# MEMORANDUM

To: Salt Lake City Historic Landmark Commission  
From: Seth Rios, Principal Planner  
801-535-7758 or seth.rios@slc.gov  
Date: February 5, 2026  
Re: Modifications to New Construction for 563 N Center Street (PLNHLC2023-00629)

The applicant is proposing a new egress window on the front façade of the home, in order to comply with Building Code. To accommodate this new window well, the applicant has shifted the front porch to the side of the front façade and rearranged the window configuration.

Figure 7: The proposed modifications shift the entrance to the right to accommodate the front window well.

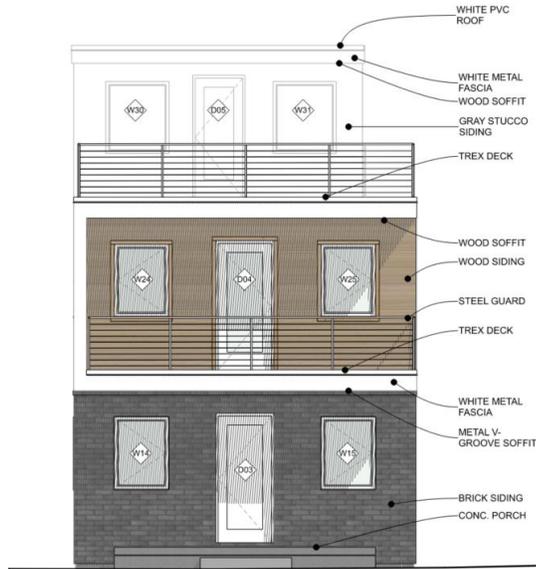
- 1) The applicant is requesting a modification to add a window well on the left side of the front façade. This window well is required by building code to provide egress for the basement bedroom. The building has no side-yard setback due to the 19-foot lot width. The applicant cannot place the window well on the north side because they do not own the northern parcel, and the building is constructed to the edge of the side lot line. They cannot place it on the south side because there would not be enough room to accommodate a driveway. There is no option to add it to the rear yard because the back half of the basement is unexcavated. Staff supports the modification request because it is required by building code and cannot be provided on a different façade.

- 2) The front entrance and concrete porch were moved to the right side of the front façade to accommodate the new window well. The entrance will have the same dimensions and fiberglass material as approved previously. The relocation of the entrance is an improvement over the previous design. An asymmetrical façade, with an offset front entrance, is a common feature along Center Street, even across different architectural styles. The proposed modification does

- 3) Window openings have been rearranged to accommodate the new entrance location. They are now located to the left of the entrance. The dimensions remain the same, and the applicant is proposing the same fiberglass material and window reveal depth. The updated design continues to appropriately address the rhythm of openings established in the surrounding neighborhood. The scale of openings and the ratio of wall to openings remain the same as in the previous approval. Staff supports the proposed modification.

- 1) A new window well on the left side of the front façade, in order to provide egress for the basement bedroom.
- 2) Shifting the front entrance and porch to the right side of the front façade to accommodate the new egress window.
- 3) Rearranging the windows of the front façade to accommodate the new entrance location.

Staff recommends approval of the requested modifications, as they maintain the style of the original approval while accommodating the applicant's request for an off-street parking stall. The new design remains consistent with the standards and guidelines.

**1 EAST ELEVATION WITH CONTEXT**  
SCALE: 1/4" = 1'-0"

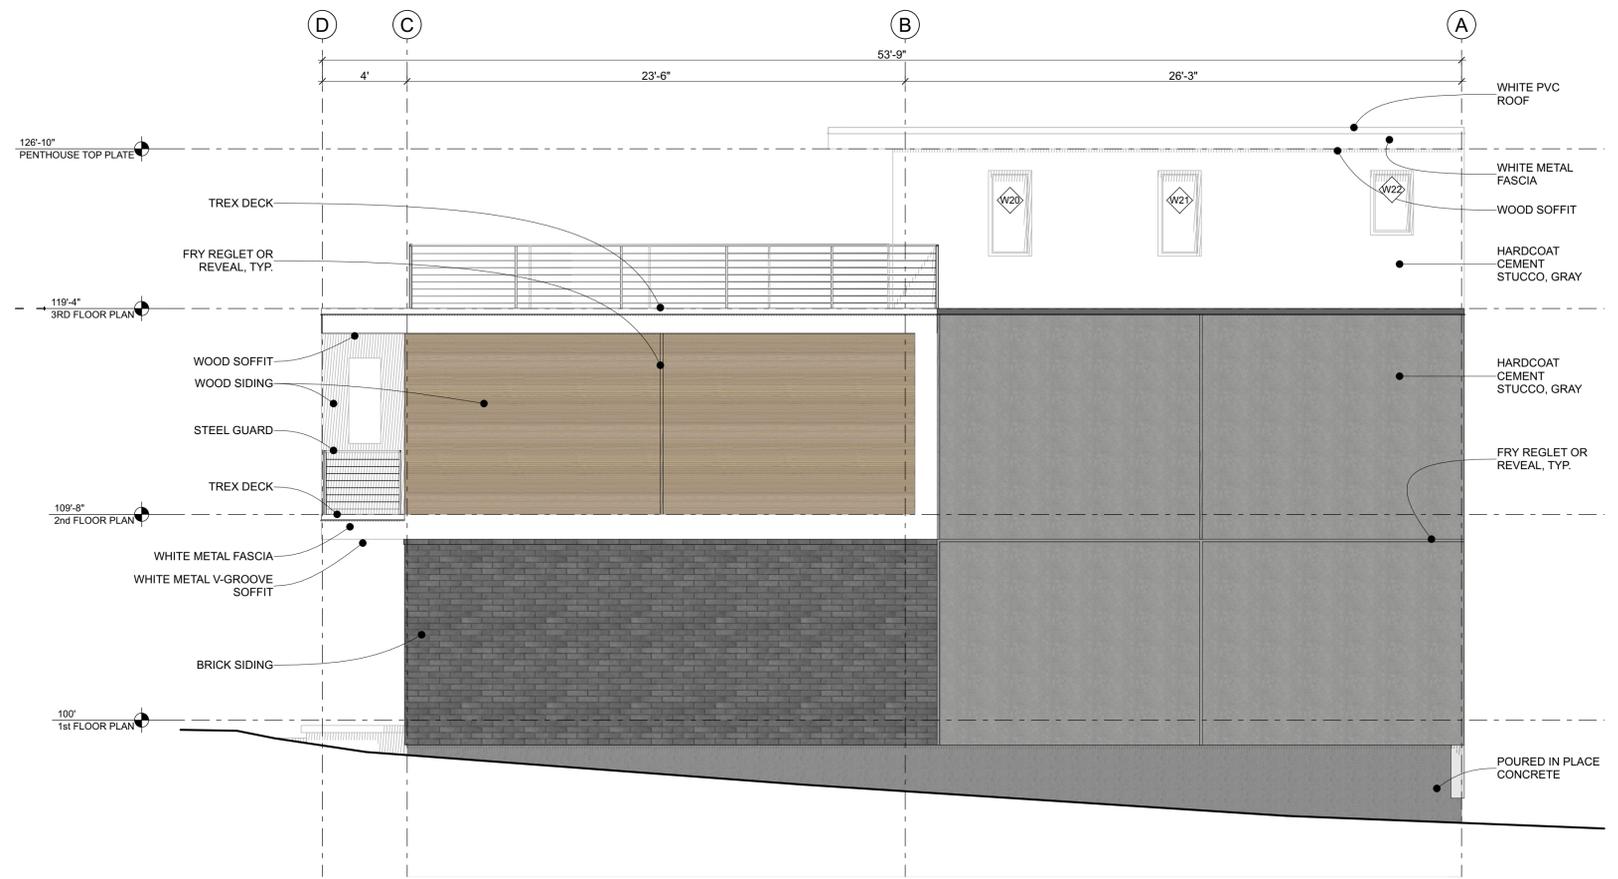
<b>Finding: Complies</b>
<b>Discussion:</b> The modified window placement on the front façade does a better job at reflecting the rhythm and openings of the block face. It is common for the homes in this neighborhood to have an asymmetrical façade, with an entrance on one side and openings on the other. This rhythm of openings is conveyed across the neighborhood's different architectural styles. The <a href="#">modifications section</a> includes several photo examples of homes in the Capitol Hill neighborhood that follow this pattern.
(2) <b>Proportion And Scale of Openings:</b> The facades are designed using openings (doors, windows, recessed balconies, etc.) of similar proportion and scale to that established in the historic context and the block face.

<b>Finding: Complies</b>
<b>Discussion:</b> The proportion and scale of all openings will not be changed by the proposed modifications. The scale and proportion of the openings will remain the same on the front façade.
(3) <b>Ratio Of Wall to Openings:</b> Facades are designed to reflect the ratio of wall to openings (doors, windows, recessed balconies, etc.) established in the historic context and the block face.
